March 2022
FL917A
NHTSA #21V-00H

Subject: FCCC Chassis Rear PDM

Models Affected: Specific model years 2016-2023 Freightliner Custom Chassis Corporation X-Line chassis manufactured November 23, 2015, through December 7, 2021, and equipped with a certain PDM.

Fig. 1, Jumper Harness Installation

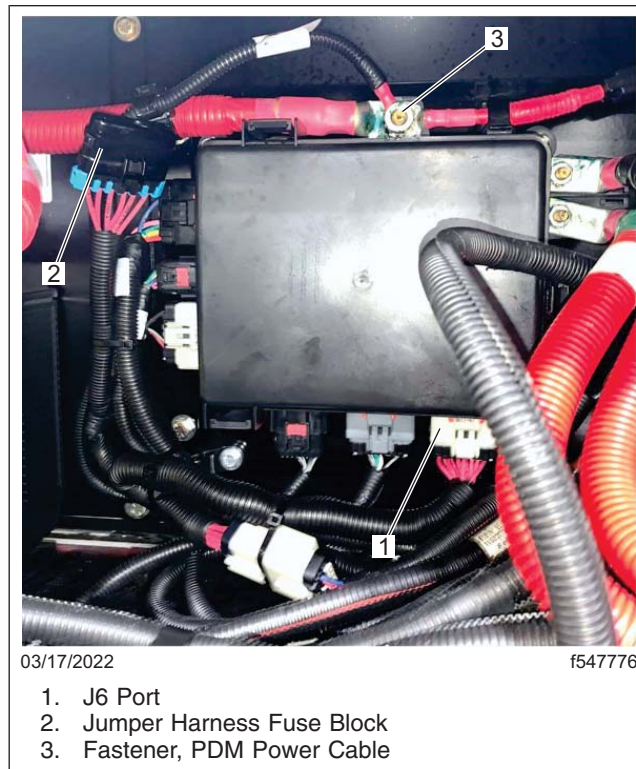
FCCC X-Line chassis, equipped with a certain rear mounted Power Distribution Module (PDM), may experience cracked internal solder joints, which after a period of vehicle use may lead to intermittent open circuits, in which the rear marker, brake lights, or left turn signal lights may not function. Brake lights working incorrectly may not notify motorists of a braking event, which may lead to an increase risk of crash.

A secondary fused harness will be added which bypasses the affected suspect portion of the PDM. Repairs will be performed by Daimler Truck North America authorized service facilities.

1. Inspect the base label (Form WAR259) for a campaign completion sticker for FL917 (Form WAR260). If a sticker is present for FL917, no work is needed. If there is no sticker, proceed with the steps below.
2. Park the vehicle on a level surface, shut down the engine, and set the parking brake. Chock the tires.
3. Disconnect the batteries.
4. Disconnect the 14-pin chassis harness connector from the power distribution module (PDM) J6 port.
5. Connect the chassis harness female connector to the A66-29948-001 jumper harness male connector. Make sure the connector is fully seated and the red tab is locked.
6. Connect the female connector of the A66-29948-001 jumper harness to the PDM J6 port. Make sure the connector is fully seated and the red tab is locked.
7. Remove the fastener that secures the power cable to the PDM power supply post.

8. Position the ring terminal of the jumper harness on the PDM power supply post, then install the fastener. Tighten the fastener 16 lbf-ft (22 N·m).
9. Using a tie strap, secure the jumper harness fuse block to the nearest harness.

10. Route the jumper harness along other harnesses, then secure it with tie straps.
11. Connect the batteries.
12. Test the function of all the rear lights.
13. Clean a spot on the base label (Form WAR259) and attach a campaign completion sticker for FL917 (Form WAR260), indicating this work has been completed.
